WATER DISTRIBUTION SYSTEM

to serve
150 N. Mclean Blvd
River Vista Apartments
CITY OF WICHITA, KANSAS
Gary Janzen, P.E., City Engineer
1905 PPW (607853)

AS BUILTS

LINES 2B & 2C AND AS-BUILT FOR ALL LINES

LINE 1

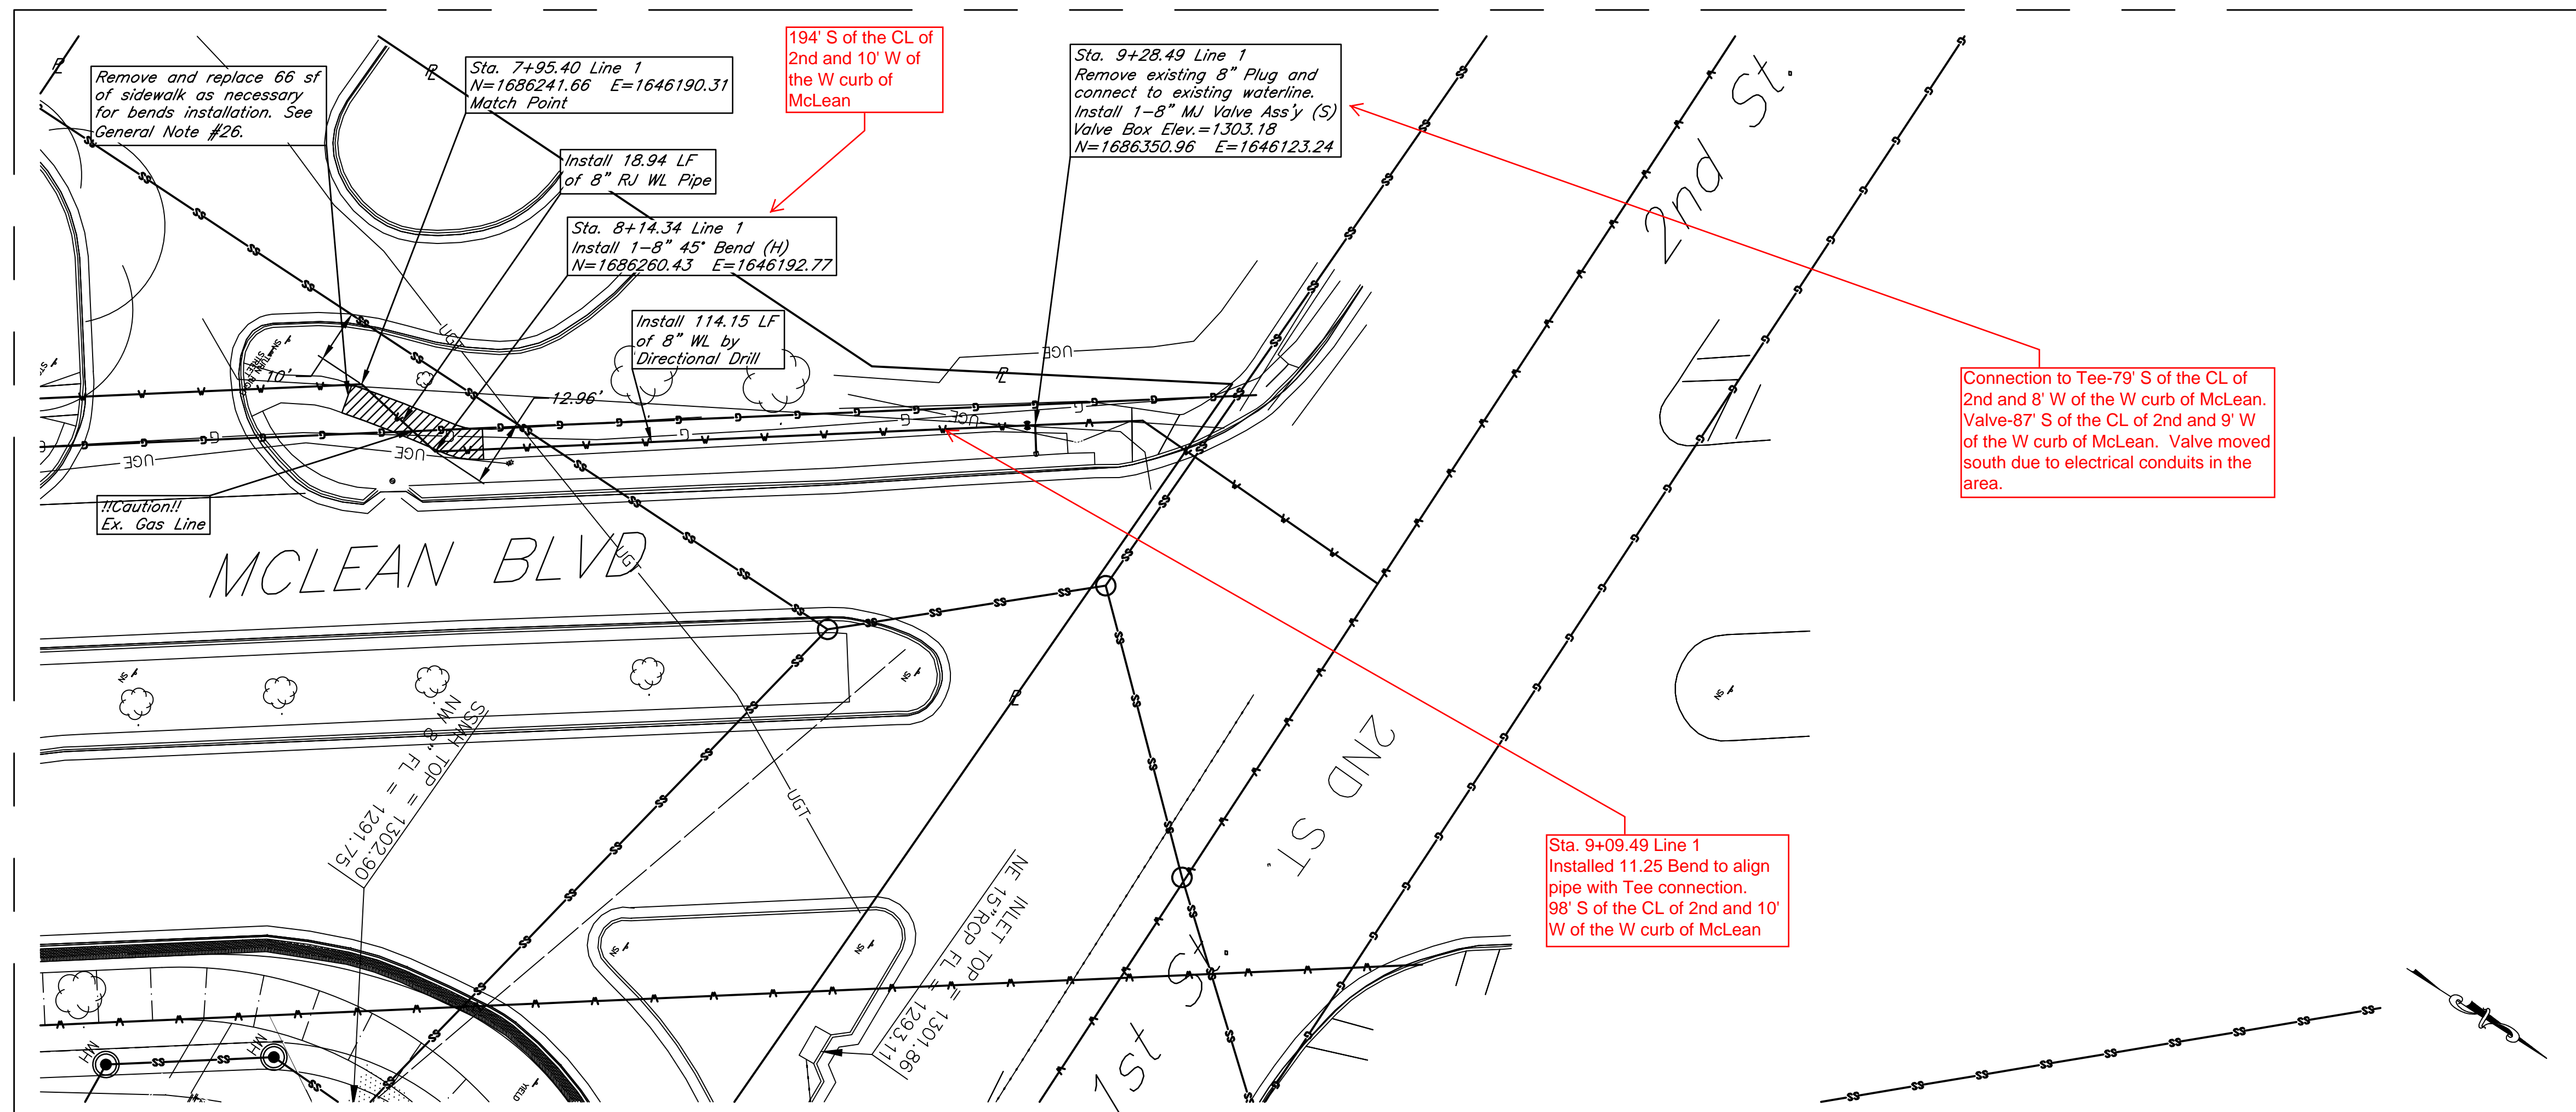
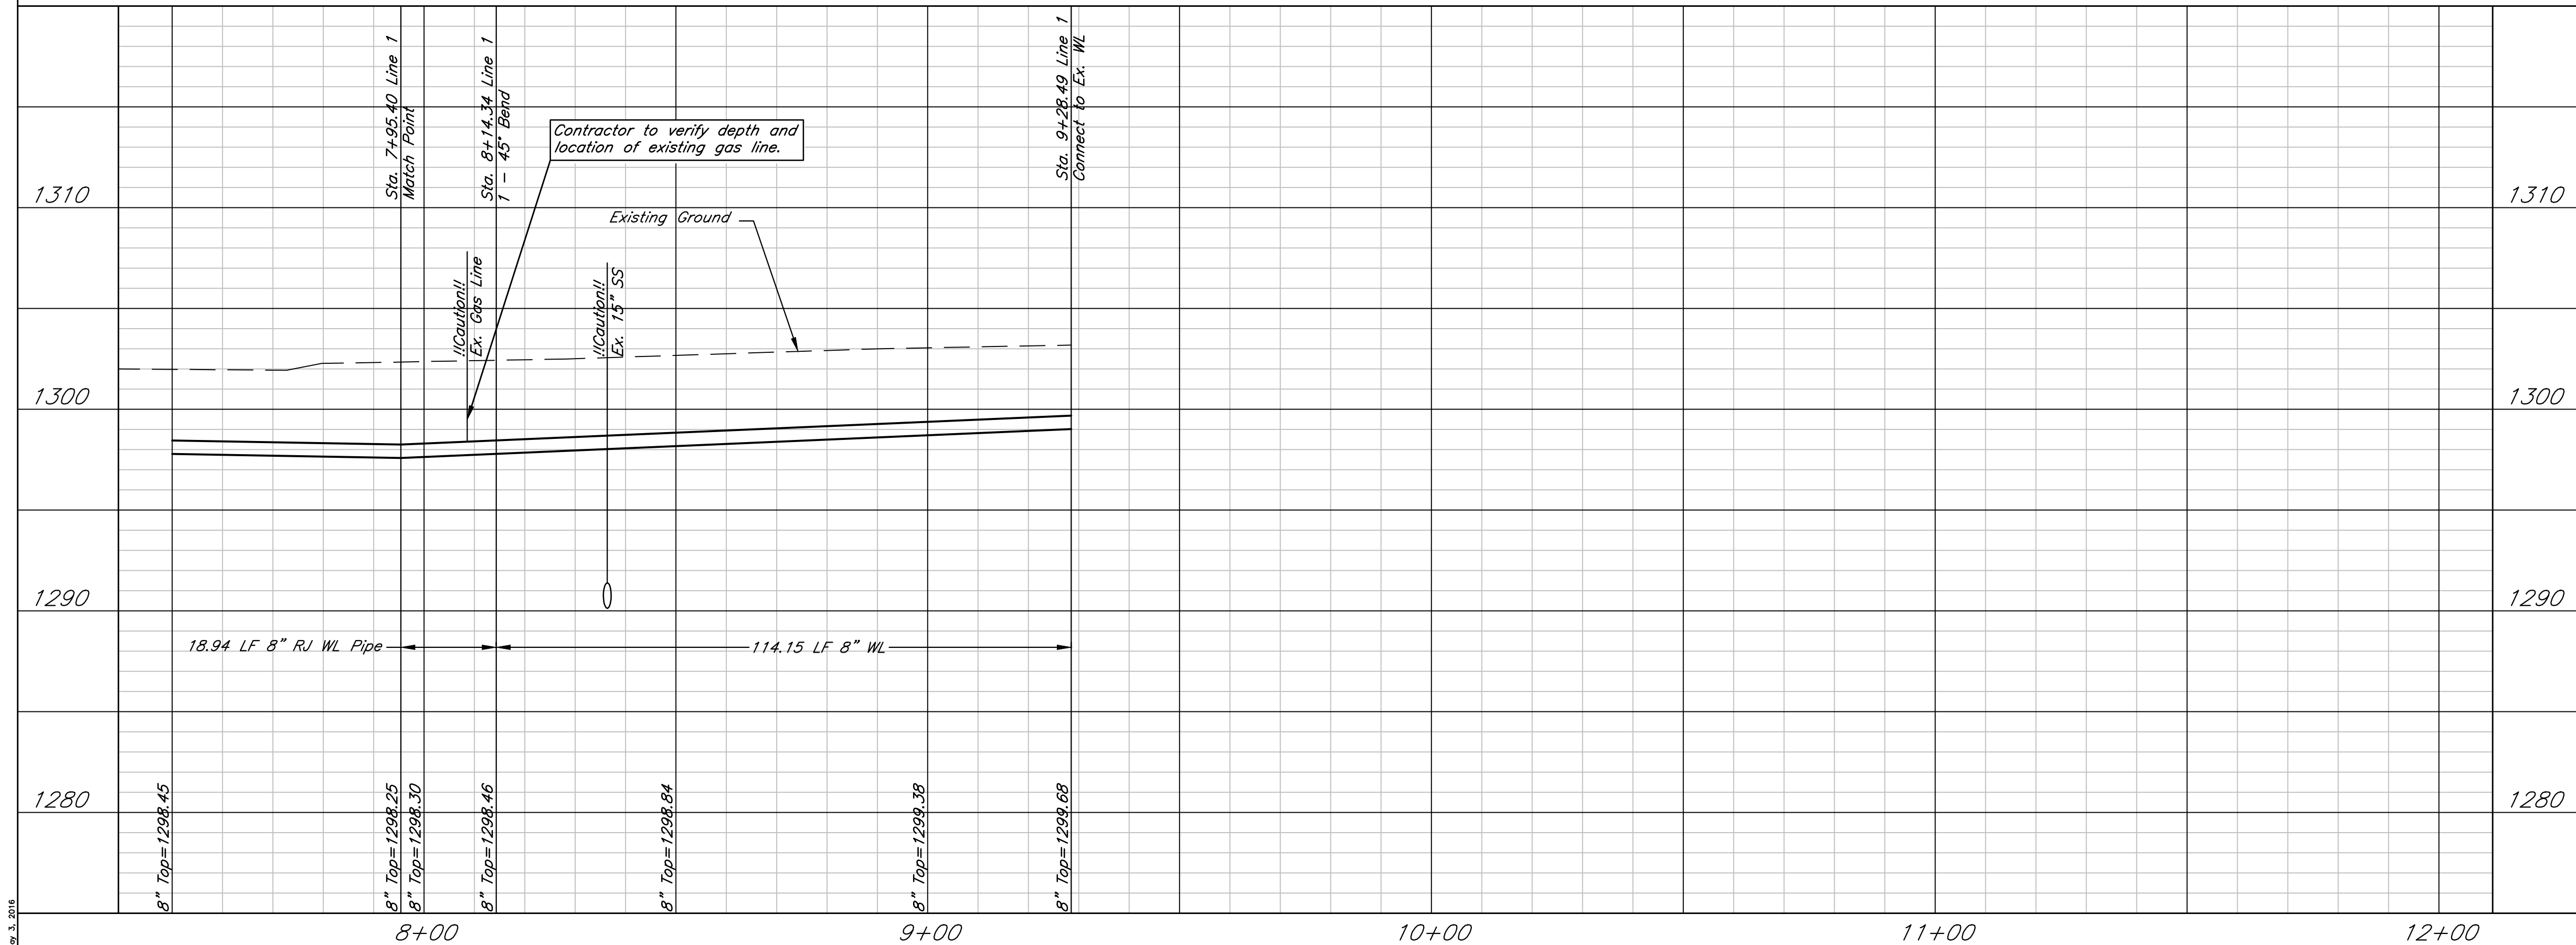
194' S of the CL of 2nd and 10' W of the W curb of McLean

Connection to Tee-79' S of the CL of 2nd and 8' W of the W curb of McLean. Valve-87' S of the CL of 2nd and 9' W of the W curb of McLean. Valve moved south due to electrical conduits in the area.

Sta. 9+09.49 Line 1
Installed 11.25 Bend to align pipe with Tee connection. 98' S of the CL of 2nd and 10' W of the W curb of McLean
